The Redevelopment of 1165R Massachusetts Avenue, Arlington

Zoning Board of Appeals Meeting 5

May 18, 2021

PROPOSED SITE PLAN – 124 UNIT PLAN

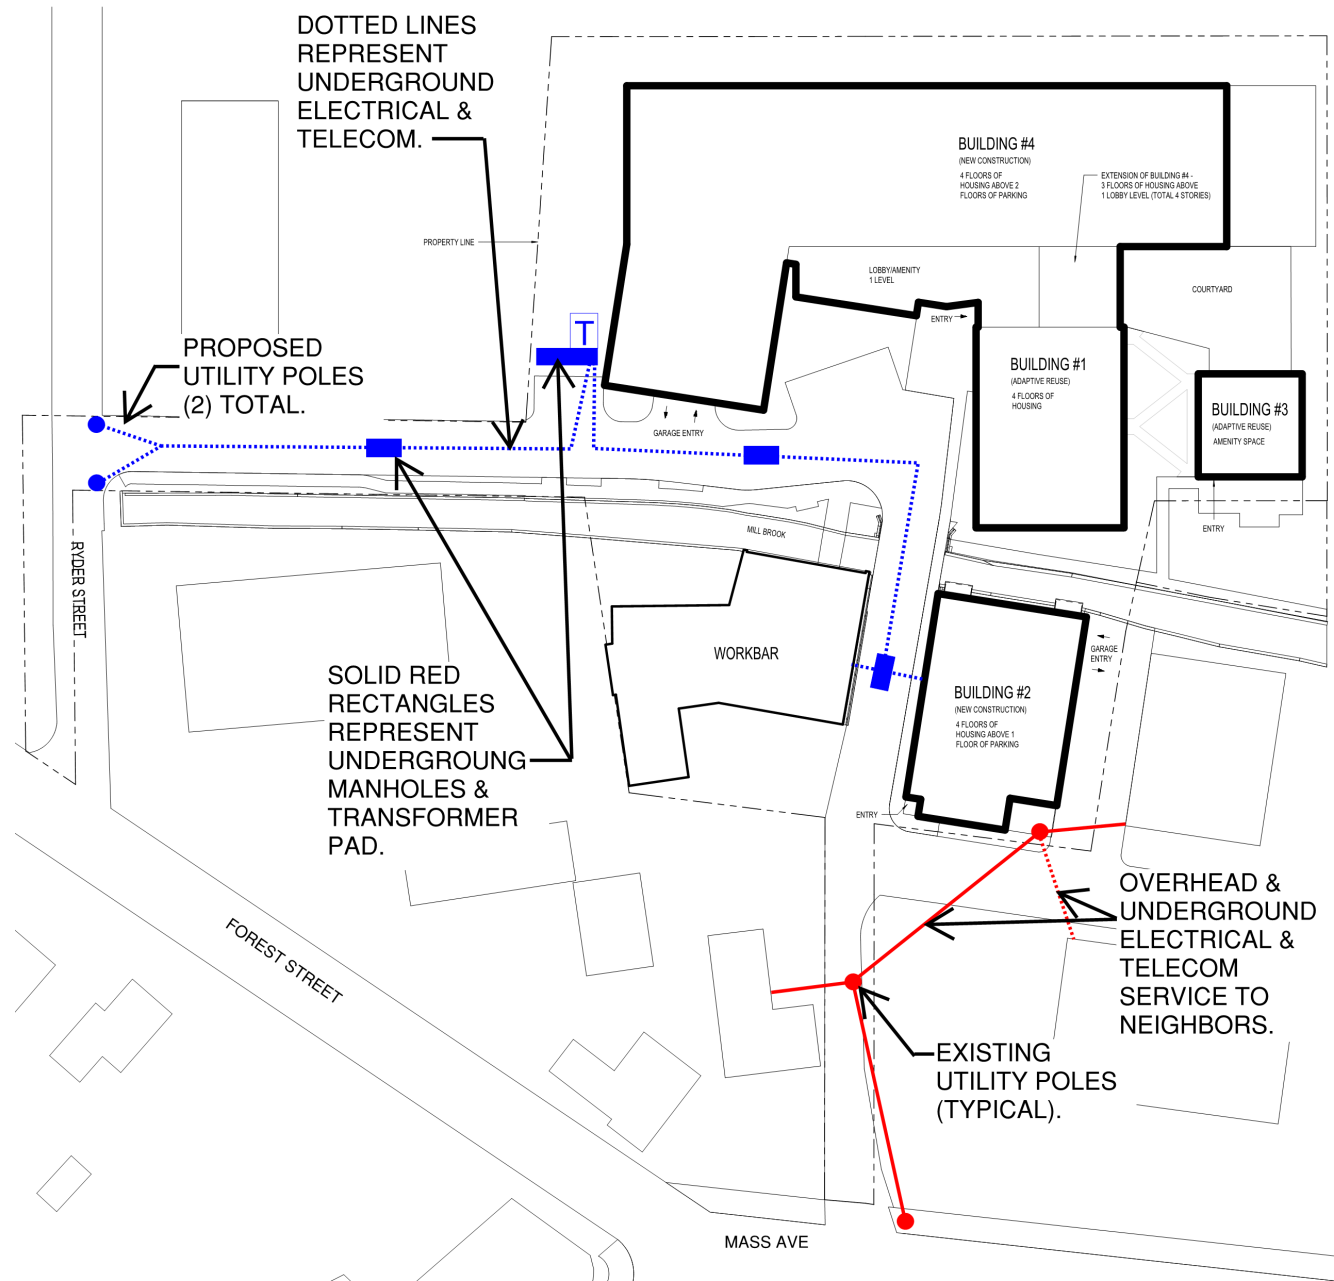
- Increased Pervious Area by 284% over existing.

- Relocated and Expanded Drainage Swale.

- Incorporated Conservation Commission suggestions for more planting adjacent to Mill Brook.

- Outdoor bicycle parking increased from 12 to 13.

- Smaller Building 4 footprint.

- Modified Building 2 footprint to accommodate electric utility pole at corner. Increases pervious area.

- Removed corridor to Building 3 improves outdoor amenity space.

BUILDING 4 – 1ST FLOOR PLAN PROPOSED

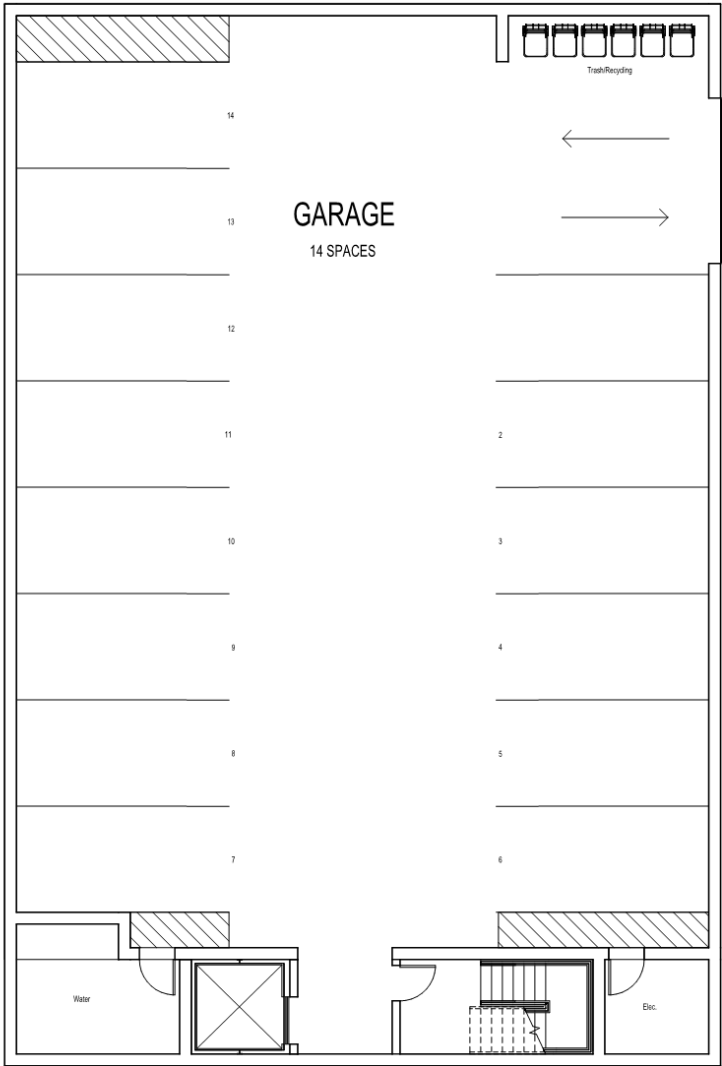
- Smaller building footprint.
- Parking in Building 4 = 96 (both levels).
- Bicycle Parking = 44 spaces per Arlington design standard.
- All amenities at ground level.
- Removed corridor to Building 3 improves outdoor amenity space.

BUILDING 2 – GARAGE & 1ST FLOOR SUBMITTED WITH CH. 40B APPLICATION

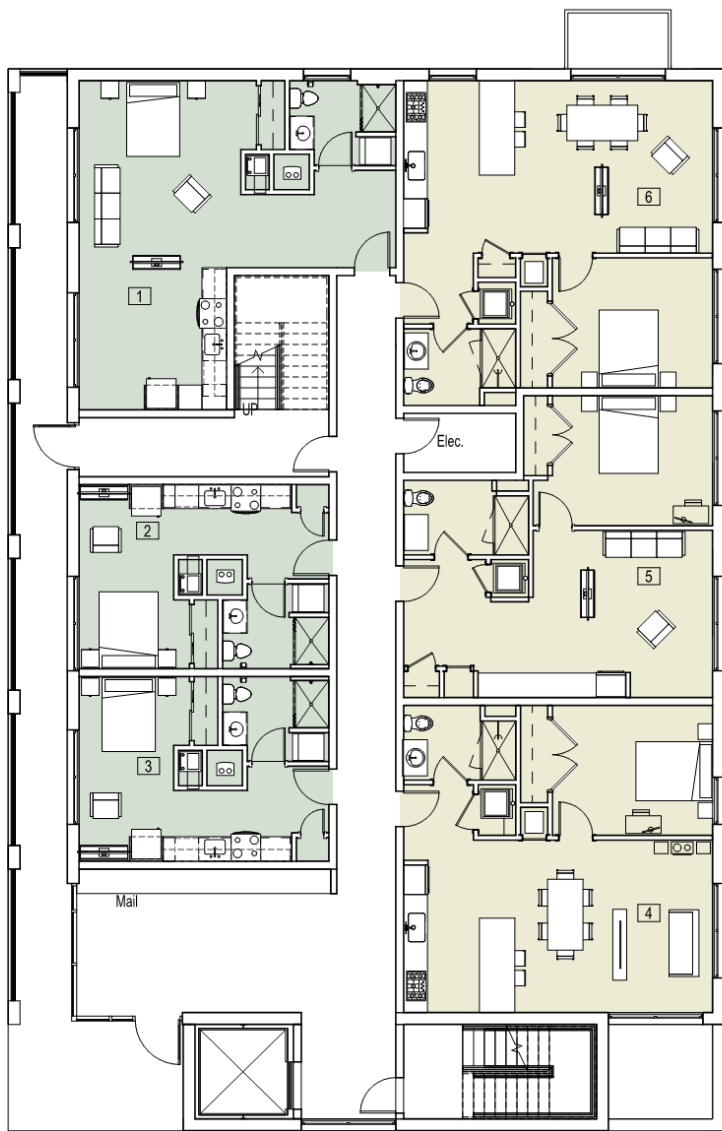
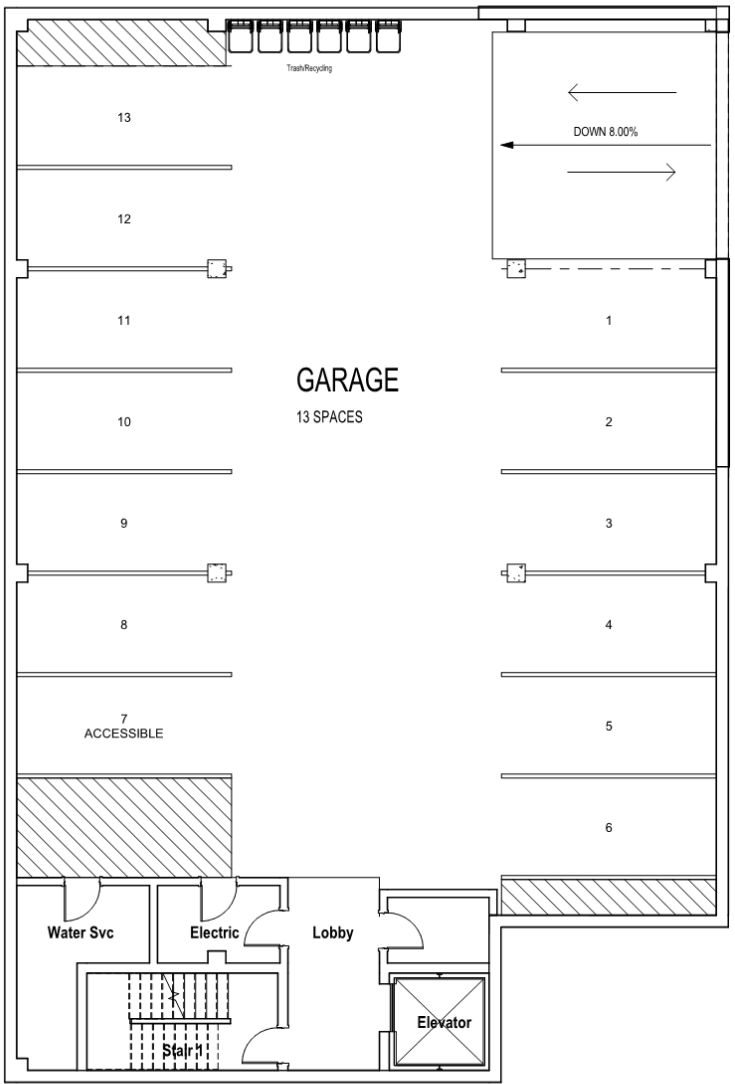
- Parking Spaces = 14.
- No change in garage access.
- Footprint does not accommodate electrical utility pole at corner.

BUILDING 2 – GARAGE & 1ST FLOOR PROPOSED

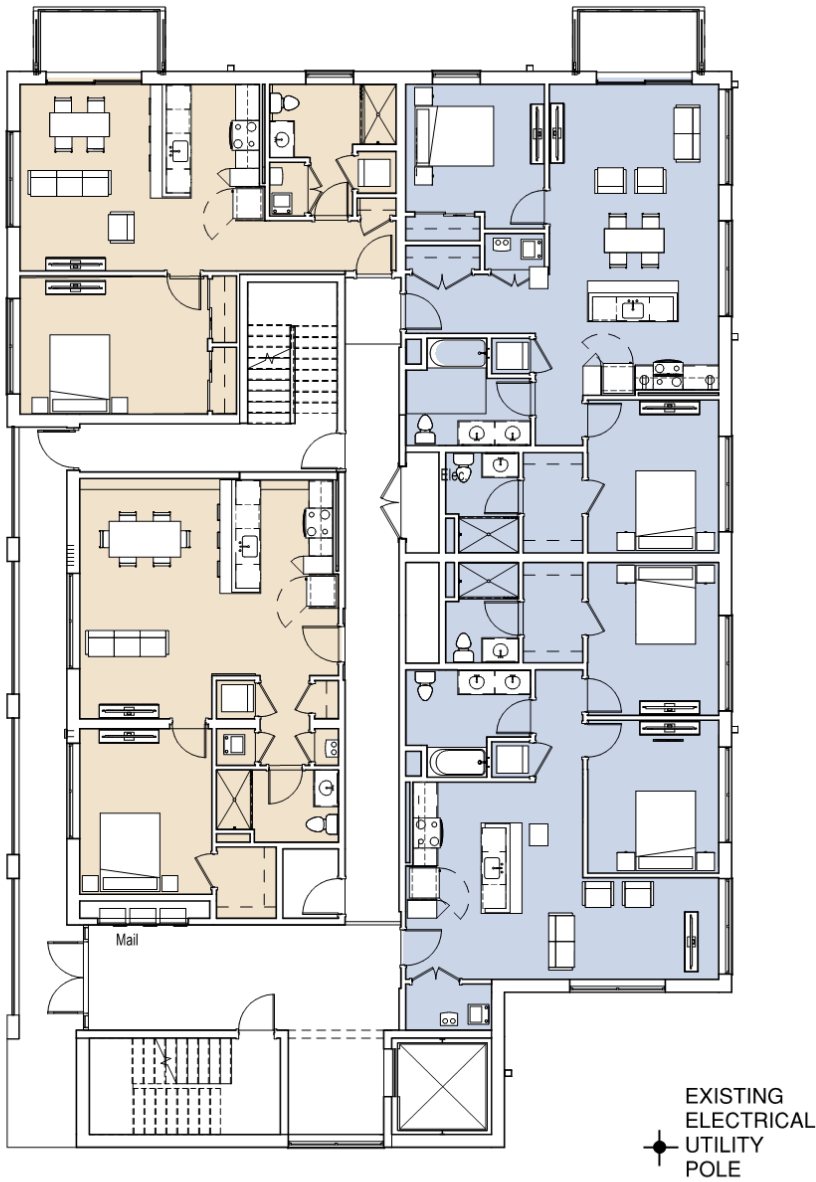
- Parking Spaces = 13.
- No change in garage access.
- Footprint accommodates electric utility pole at corner.
